BAND ON THE WALL
 PROPOSED MEZZANINE FLOOR PLAN

1387 | L 1002 REV E JULY '20 | 1:100 @ A3

PROPOSED MEZZANINE FLOOR PLAN

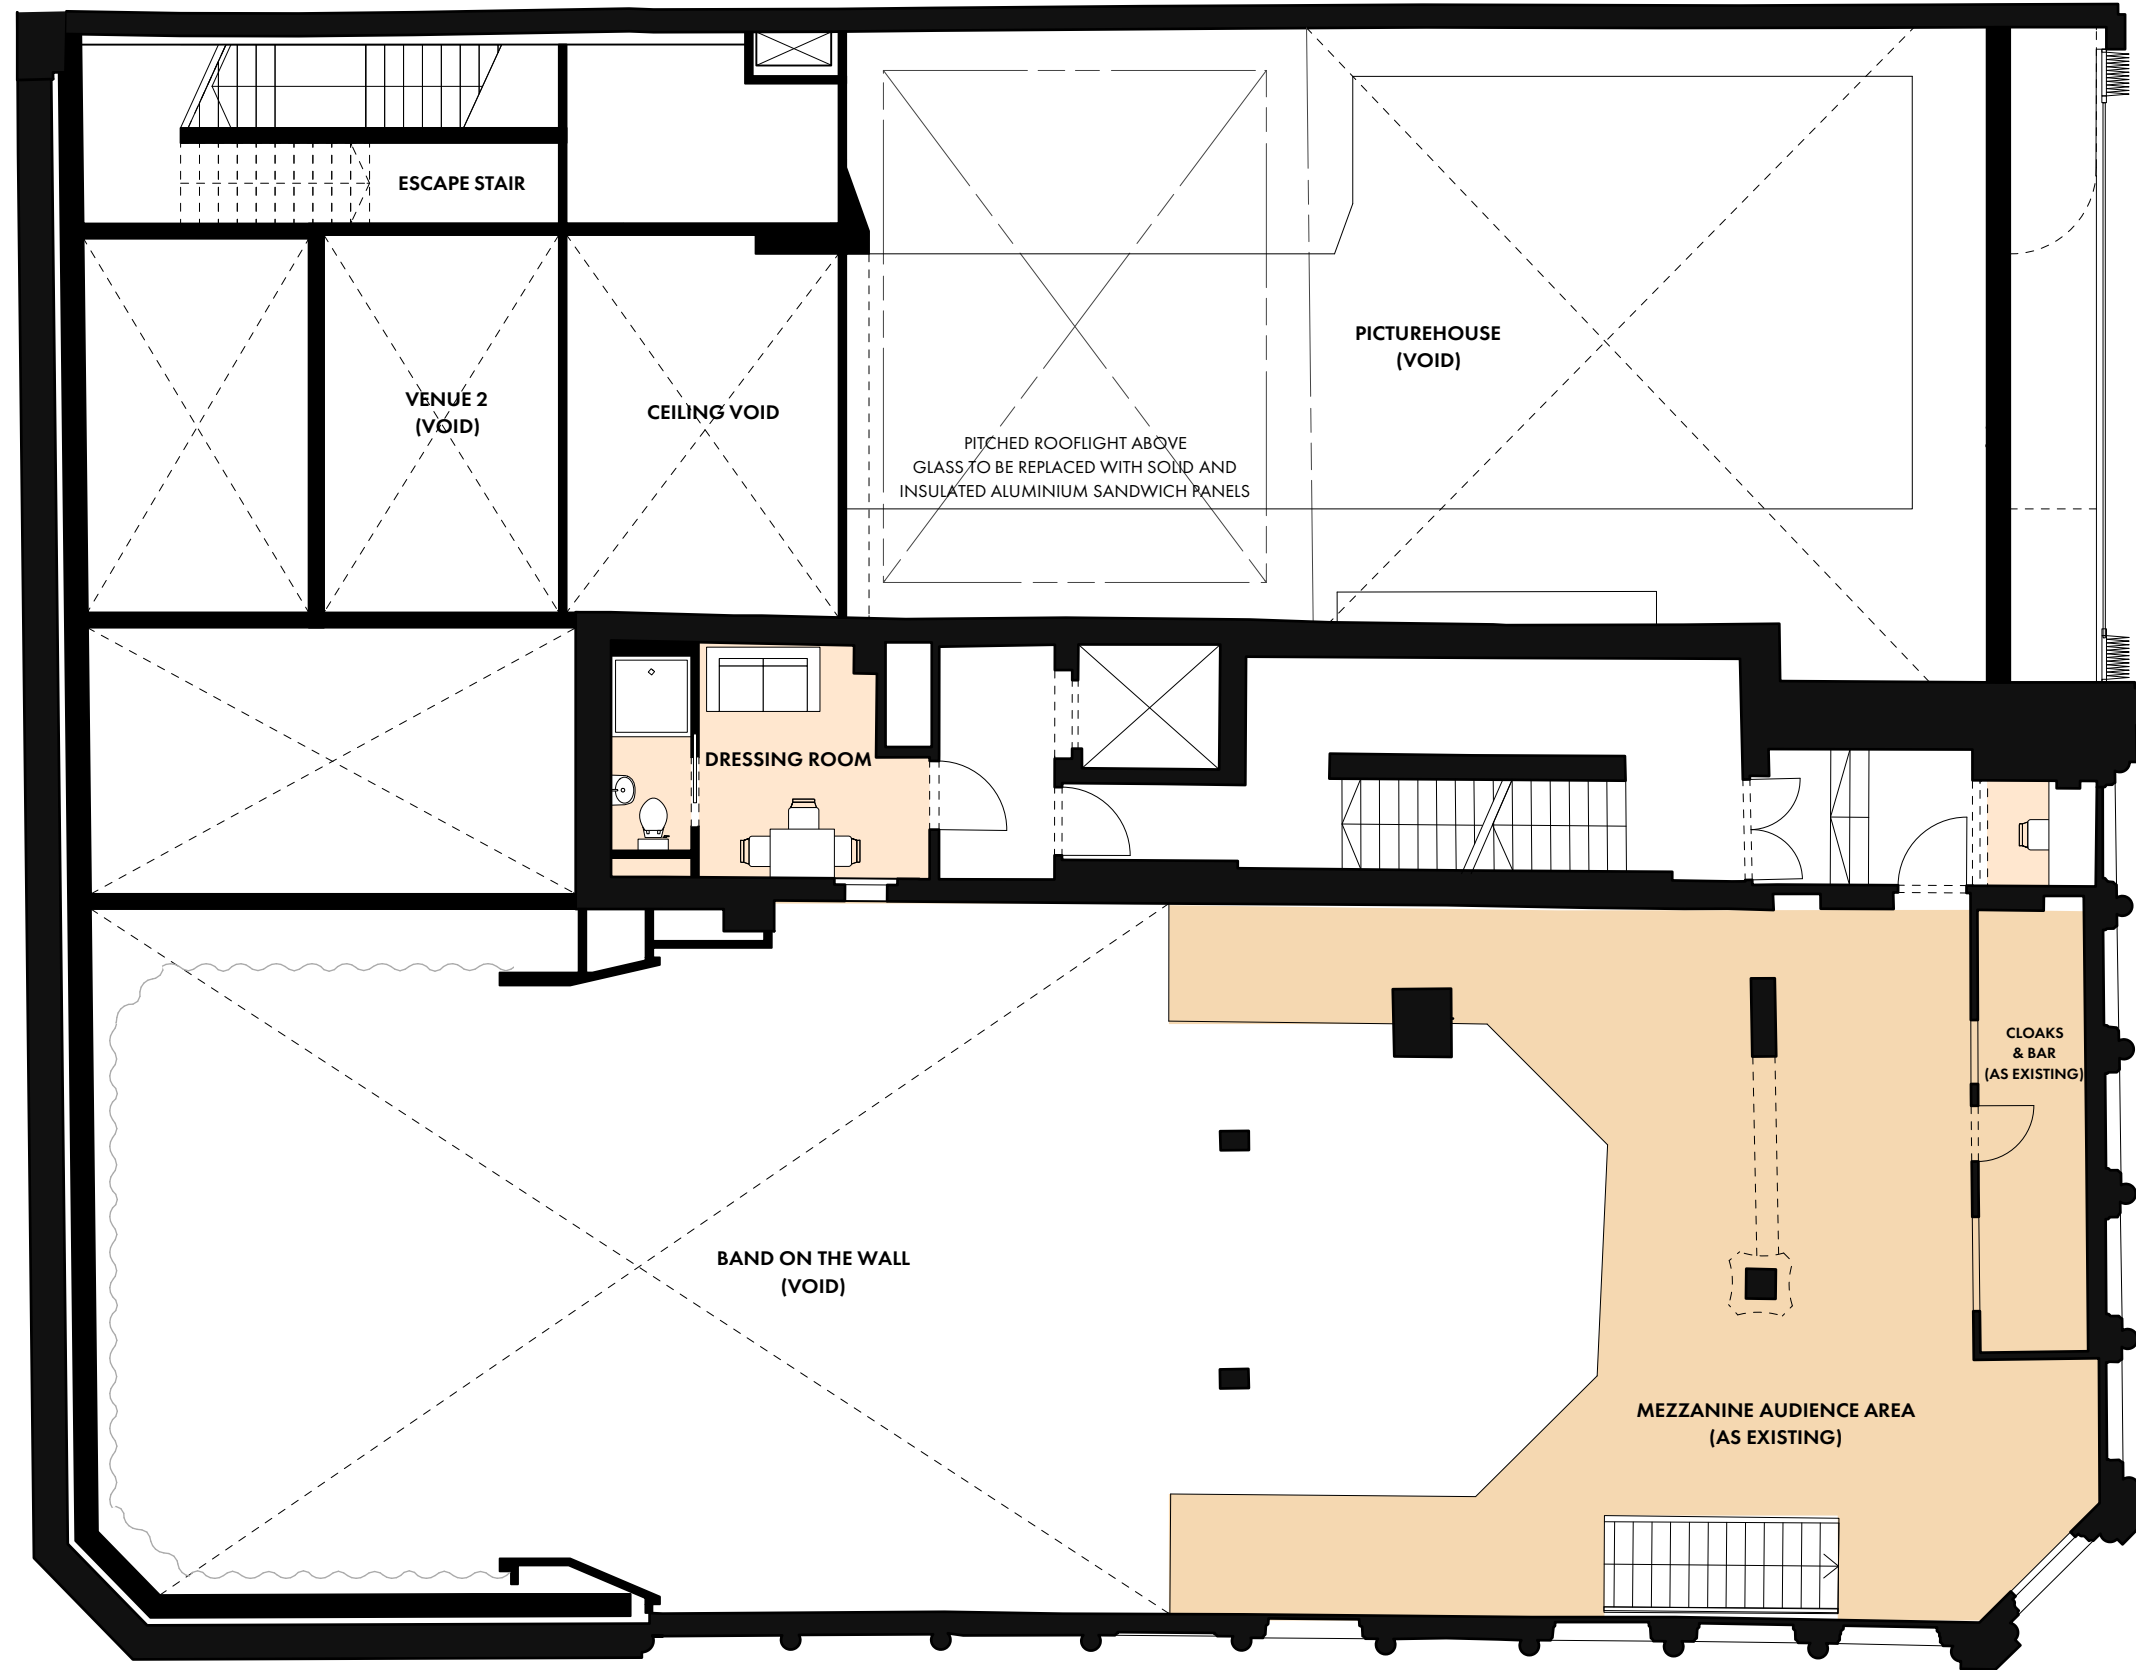
NOTES - REVISION E
 Partitions amendment to suit ground floor
 Note amended for Picturehouse rooflight work
 General amendments to Swan Street front entrance including omission of high level glazing - refer to elevation drawing
